BID MEMO 01

<u>Saints - Cafeteria & Viewing Area</u>

REVISION #01

New Orleans Saints Viewing Area and Cafeteria Expansion 5800 Airline Drive Metairie, Louisiana 70003

DRAWN BY | Author A8.61

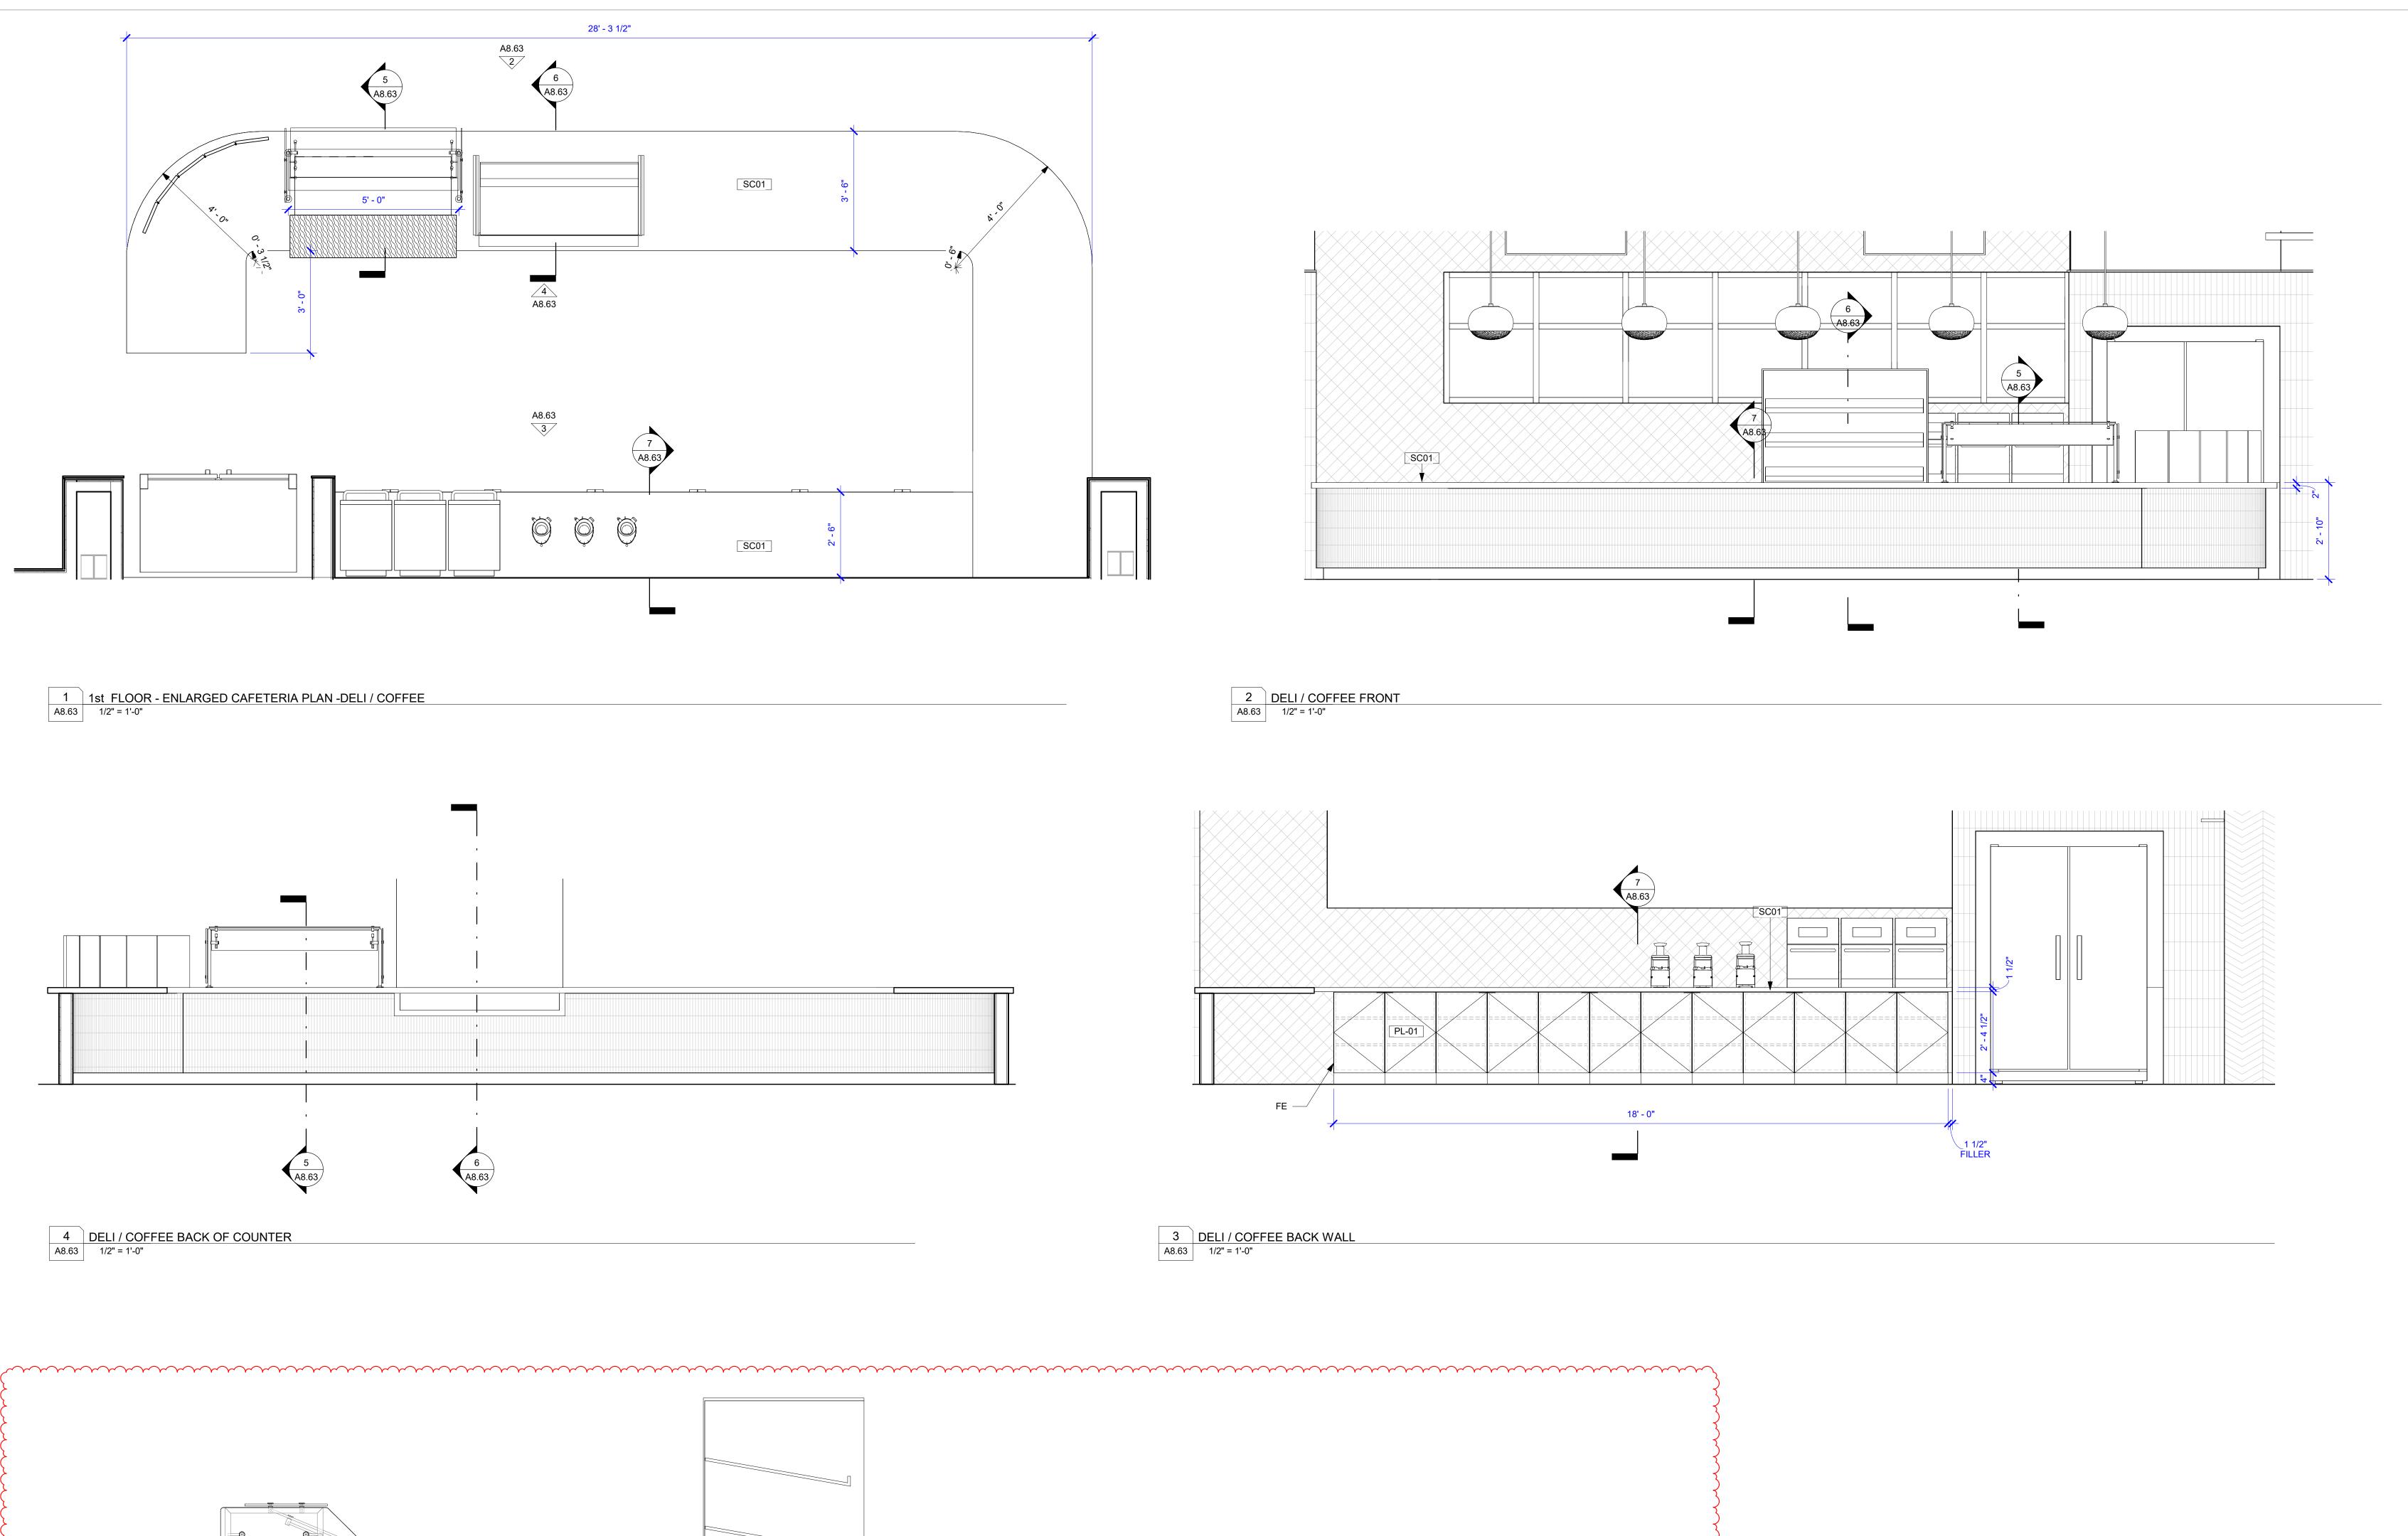
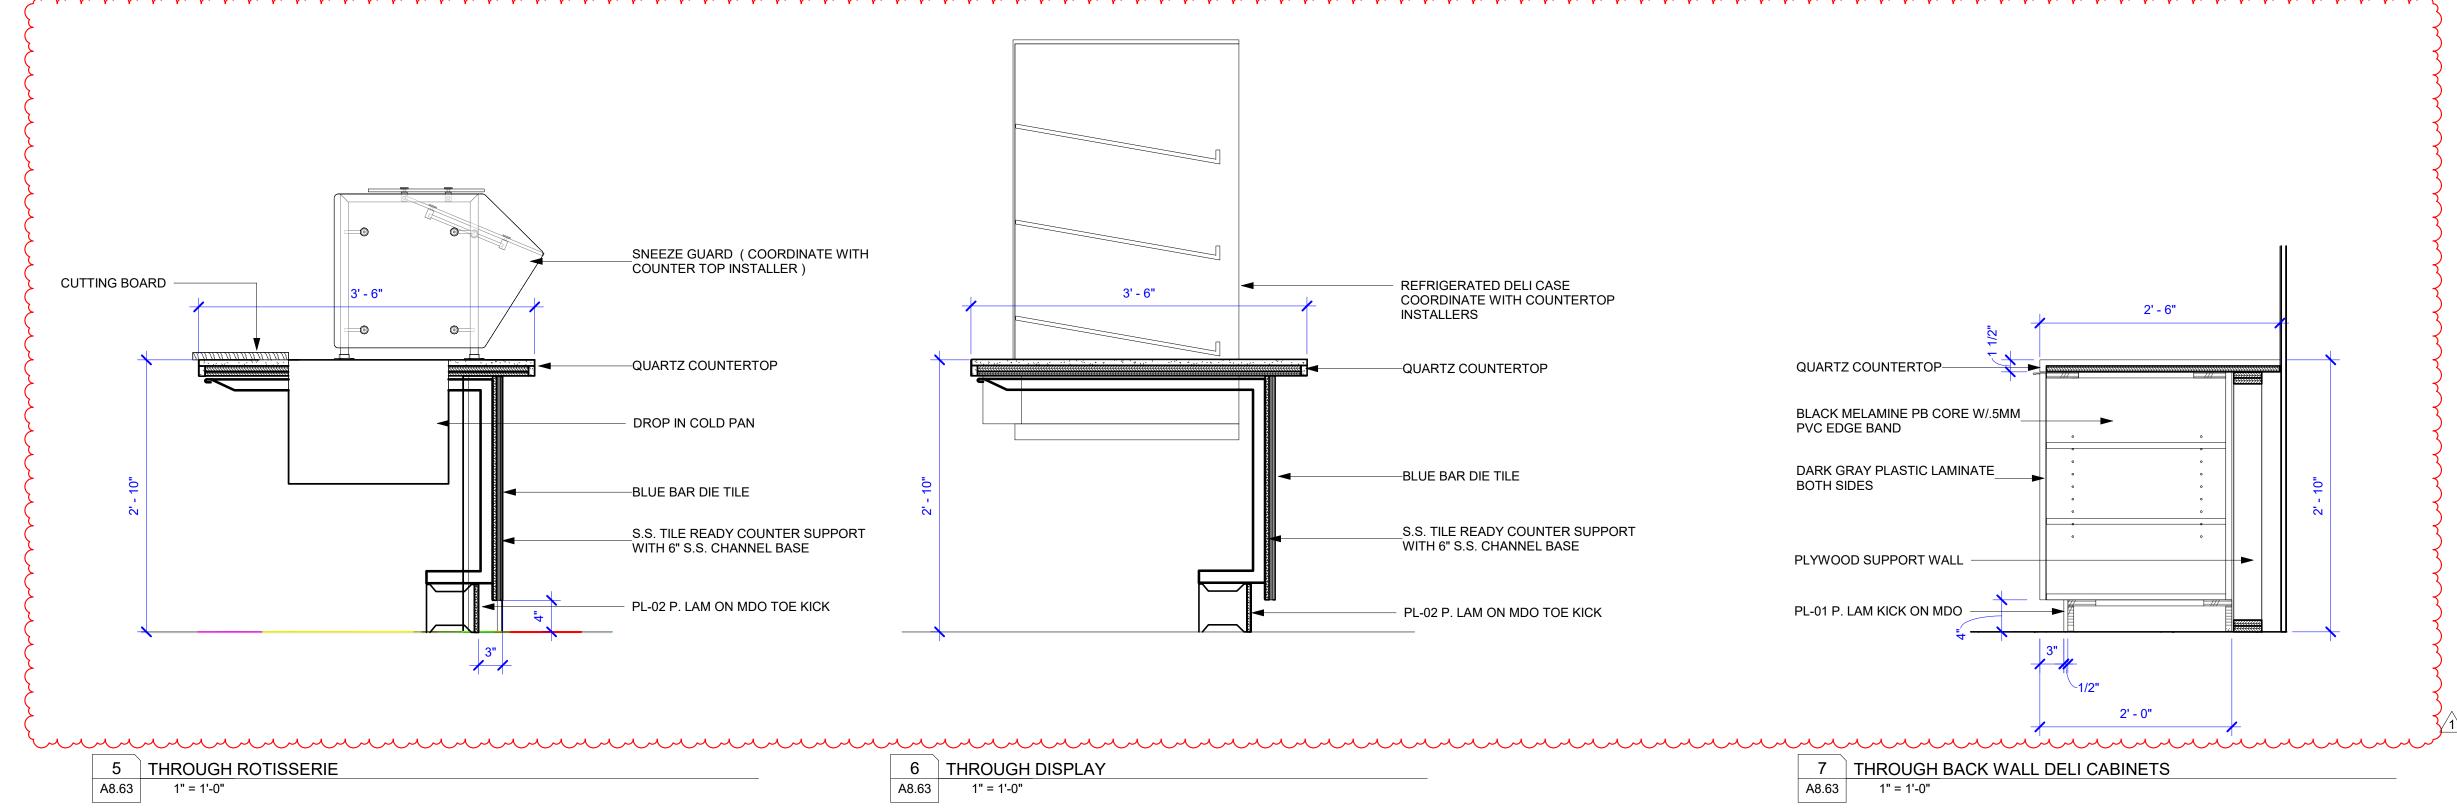
- 2 keys notes added for new schulter strips A8.10
- Plastic laminate adjustment at toe kicks- A8.60, A8.61, A8.63
- Updated edge condition at countertops (2" typ.) 7/A8.61

6 FLOOR 2 FINISH PLAN - CASEWORK
A8.64 1/2" = 1'-0"

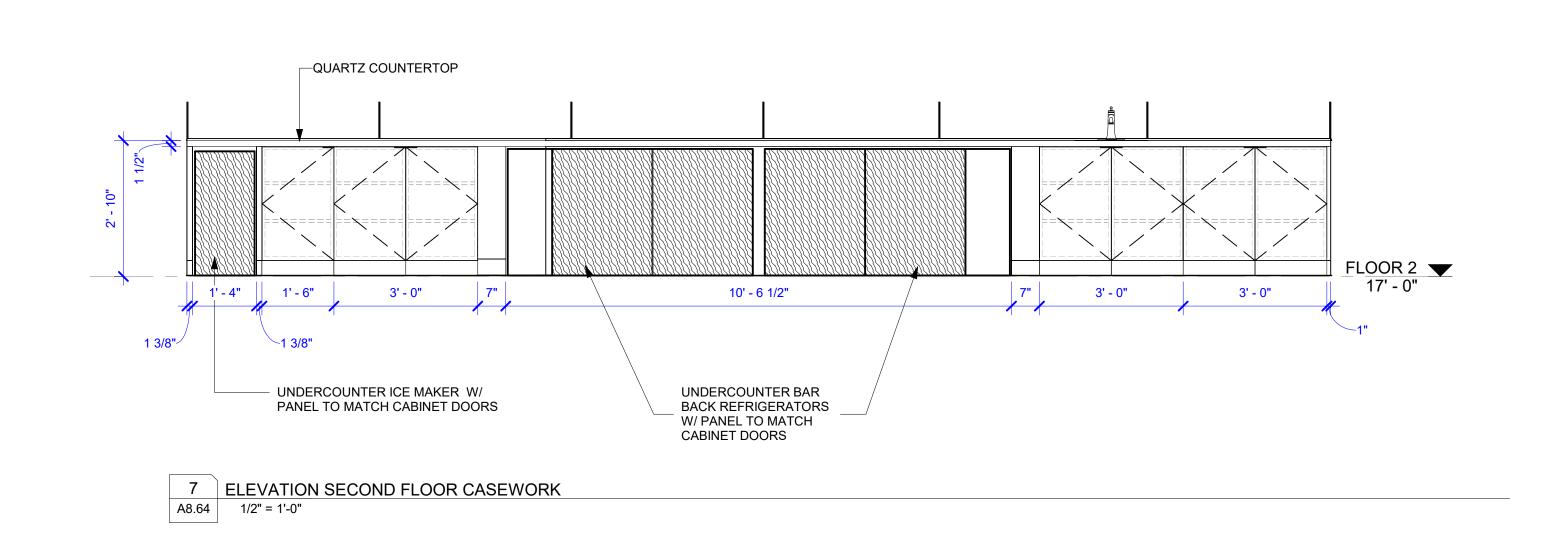
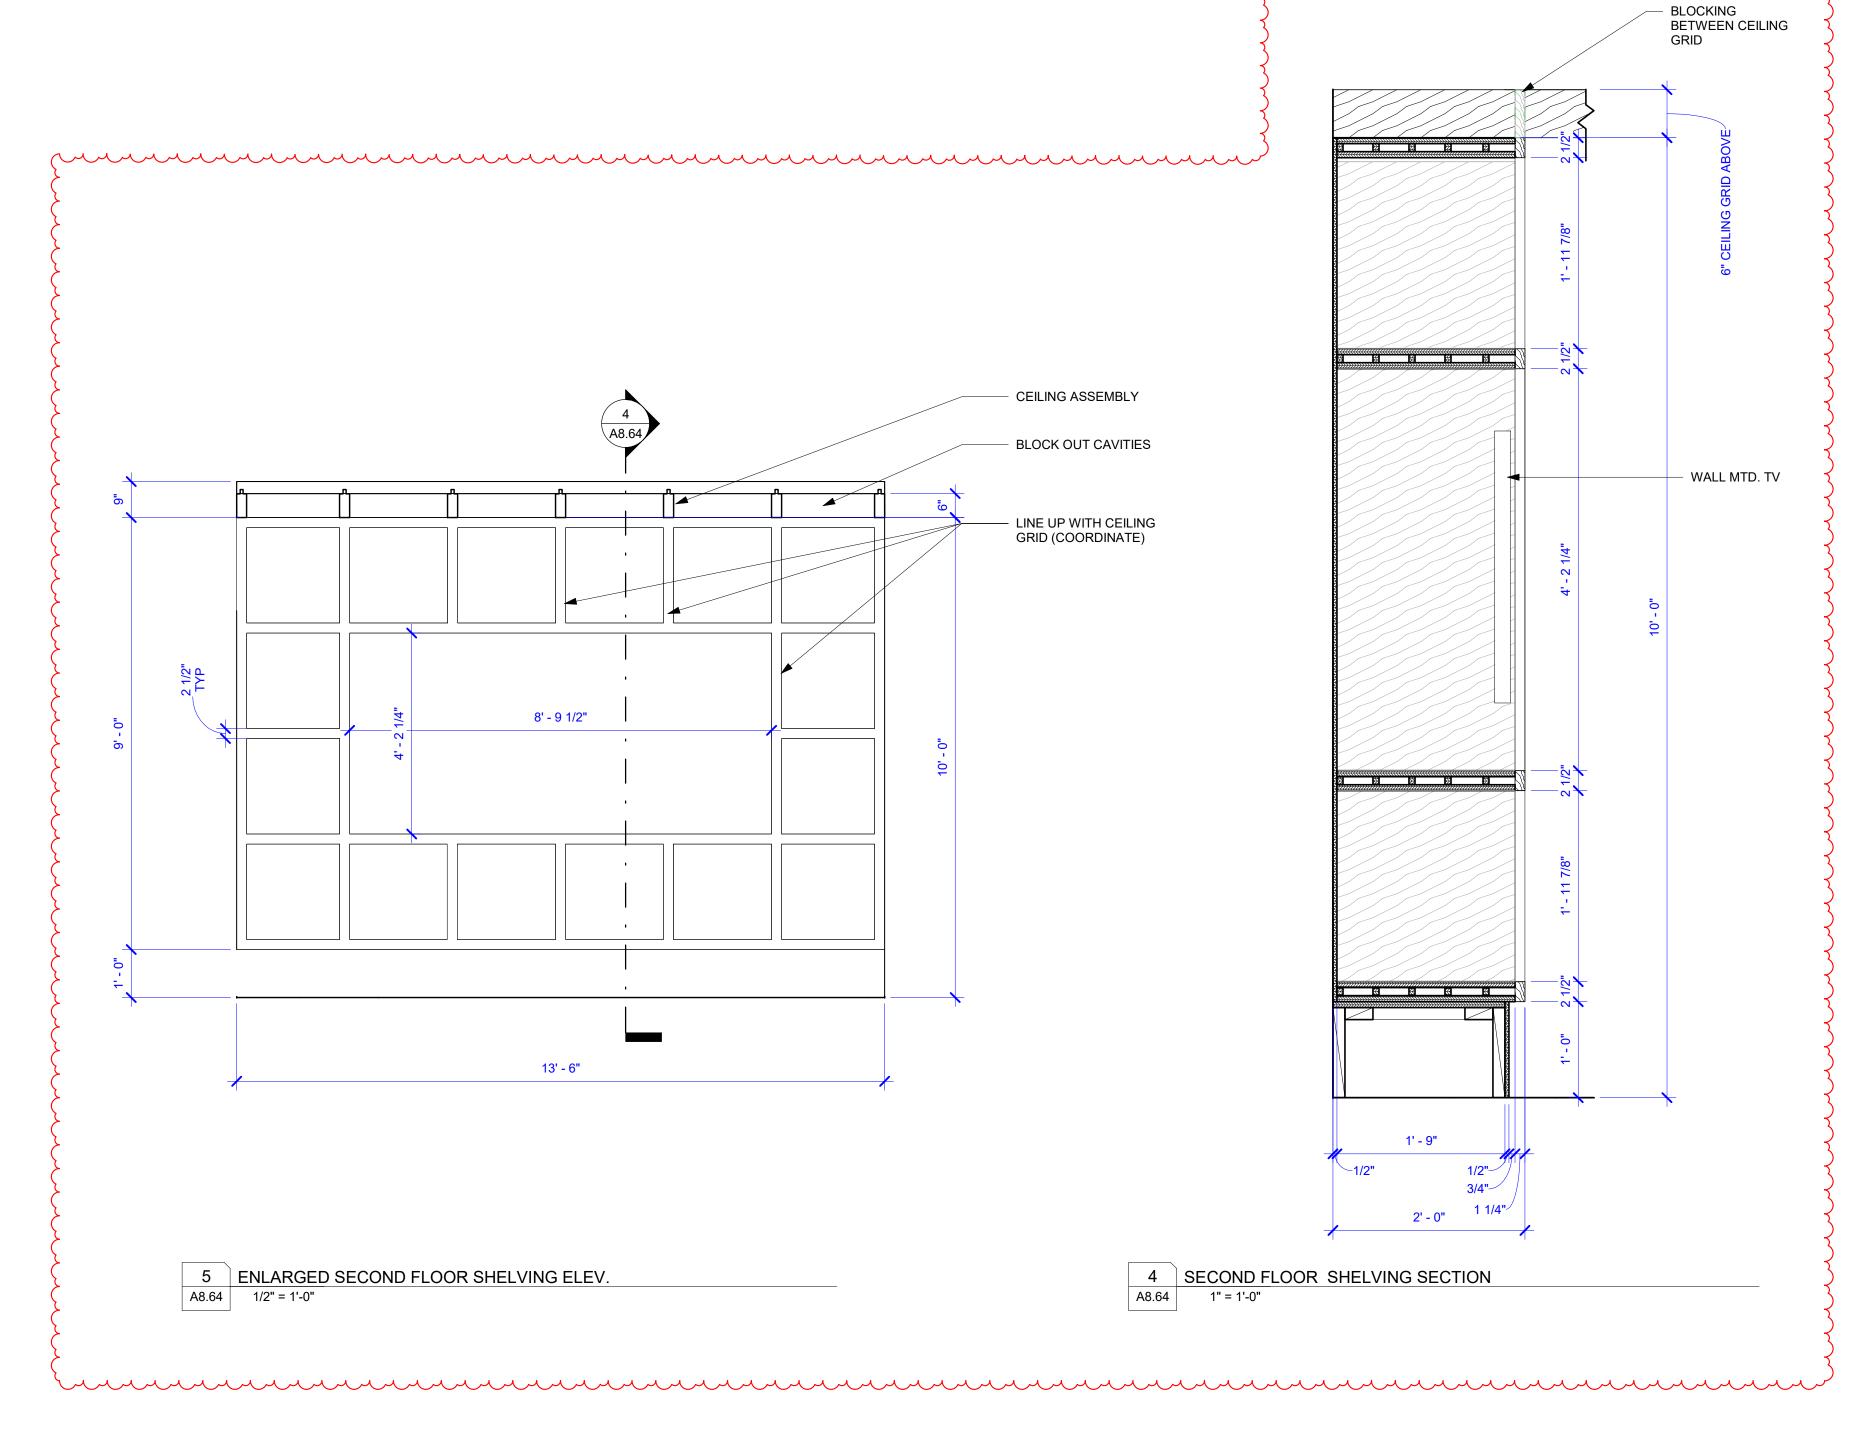
- Revised and dimensioned grab and go millwork A8.64
- Revised shelving to align with ceiling grid A8.64
- Revised design code year and live load information So.o
